**Subject: Submittal of License Condition S-2 Authorized Changes**

Reference: Docket No. 70-143: SNM License 124

**NFS License Condition S-2 Change Discussion**

**Figure 2-1: Functional Organization Chart**

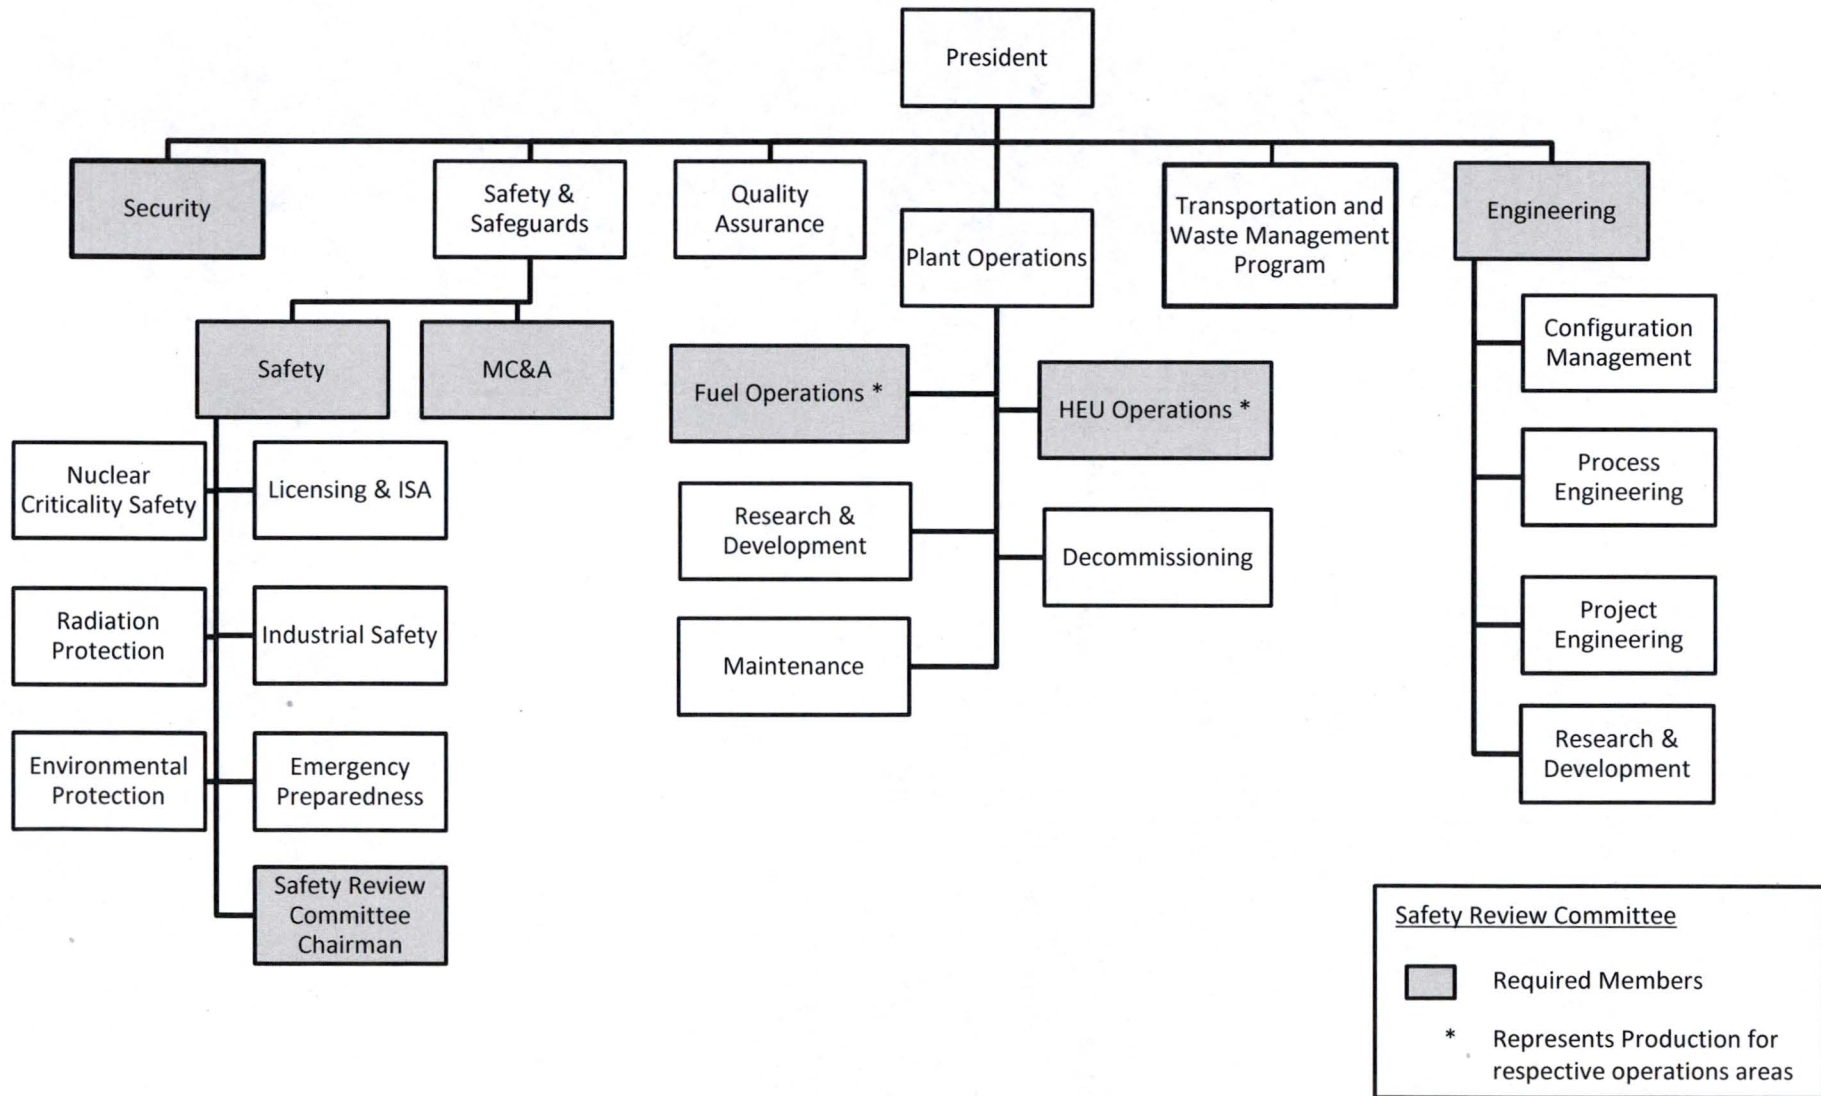
The changes to Chapter 2 are administrative in nature and include the updated Functional Organization Chart reflecting the Security Organization reporting change and the Transportation and Waste Management Program reporting change. Please see the Enclosure for a copy of SNM License 124, Chapter 2, with changes denoted by vertical lines in the right margin of affected pages.
